Field Engineering Bulletin
071 8283 03 | February 12, 2005
Reference ECO: 330L

Broadlinx 2.2.1 Upgrade

Figure 12.

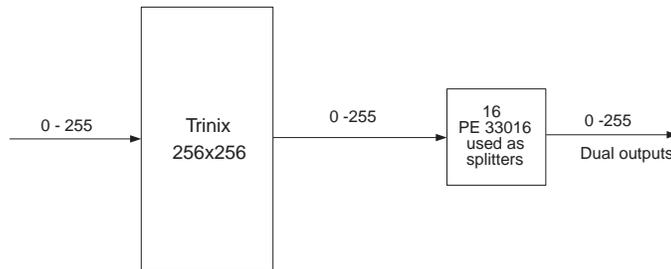
- 1. Output duplication** (dual/quad outputs) requires output splitters and output gain increase. See Figure 12 for an example.

The necessary gain increase is accomplished by

- Closing the rear-panel *Input Expand* DIP switch, and
- Setting the output board jumpers (or DIP switches) to the “Expand Enable” position (as shown on page 18 and page 19).

Figure 13.

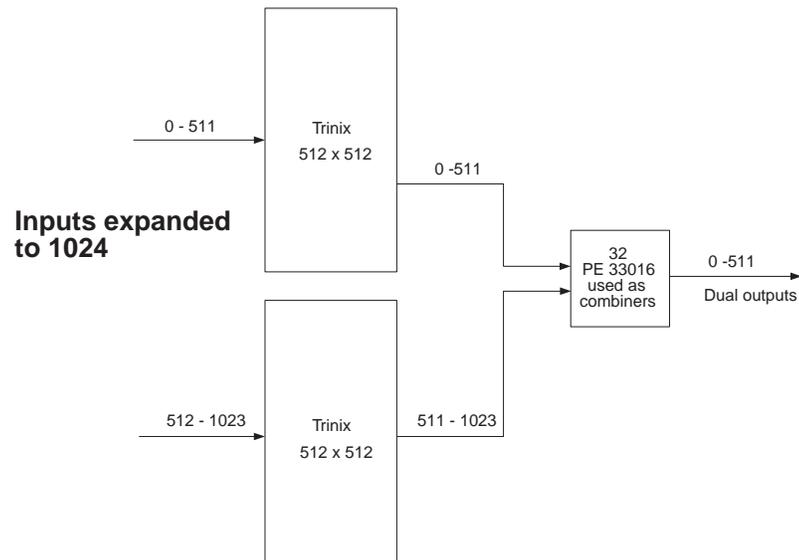
- 2. Input expansion** requires *output* combiners and *output* gain increase. See Figure 13 for an example.

The necessary gain increase is accomplished by

- Closing the rear-panel *Input Expand* DIP switch, and
- Setting the output board jumpers (or DIP switches) to the “Expand Enable” position (as shown on page 18 and page 19).

Figure 14.

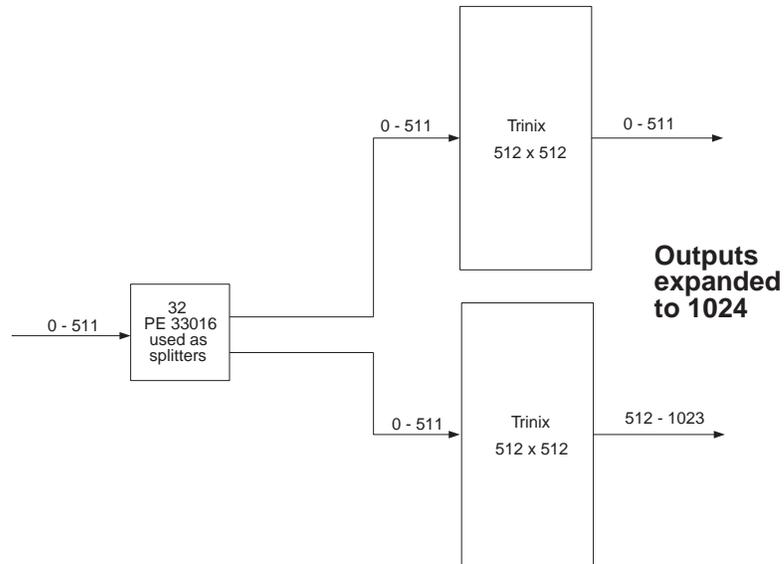
- 3. Output expansion** requires *input* splitters and *input* gain adjustment. See Figure 14 for an example.

The gain increase is accomplished by closing the rear-panel *Output Expand* DIP switch. This will provide the proper gain increase for all input boards in the chassis.

Figure 15.

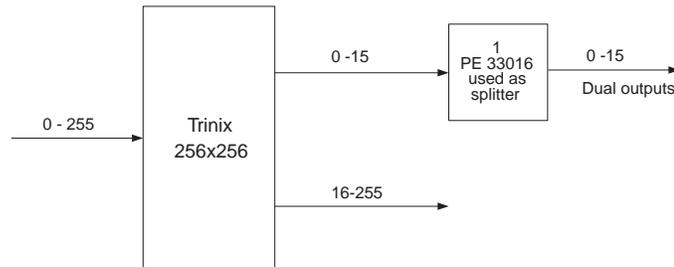
The PE-33016 Port Expander can be used to provide dual outputs in groups of 16 outputs, while the PE-33008 Port Expander can be used to provide quad outputs in groups of 16 outputs. For example, Figure 15 shows outputs 0-15 with dual outputs and the remainder with single outputs.

- For SO-33110/33011 and HO-33110/33011 output boards, the gain for outputs 0-15 is boosted by closing the rear-panel *Input Expand* DIP switch and verifying that the **on-board jumper** for that set of outputs is in the “Expand Enable” position. The location of the boost jumper on these output boards is shown on page 18. The gain for outputs 16-255 must be held at unity by setting the on-board jumpers for that set of outputs to the “Force Normal” position; this overrides the rear-panel DIP switch setting for those outputs.

- For HO-33120/33121 output boards, the gain for outputs 0-15 is boosted by closing the rear-panel *Input Expand* DIP switch and verifying that the **on-board DIP switch** for those outputs is closed. The location of the DIP switches for these boards is shown on page 19. The gain for outputs 16-255 must be held at unity by opening the on-board DIP switches for that set of outputs; this will override the rear-panel DIP switch setting for those outputs.
